Central Valley Regional Water Quality Control Board

29 May 2020

ORDER AMENDING CLEAN WATER ACT SECTION 401 TECHNICALLY CONDITIONED WATER QUALITY CERTIFICATION; VULCAN MATERIALS COMPANY, AUSTIN QUARRY PROJECT (WDID#5B20CR00077), MADERA COUNTY

Figure 1- Temporary Impact Areas

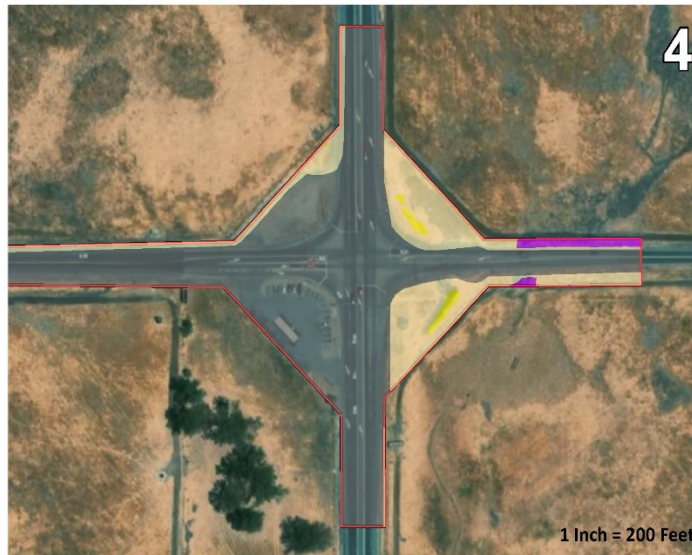
The original project certification is amended to reflect an increase in temporary impacts to waters as a result of Caltrans required modifications to State Route 145 to improve traffic safety. The modifications may result in temporary direct impacts to 0.016-acre of existing culverts through in-kind replacement. Temporary indirect effects associated with the State Route 145 improvements may occur in up to 0.14 acre of vernal pools, 0.08 acre of seasonal wetland depressions, and 0.01 acre of ephemeral drainages.
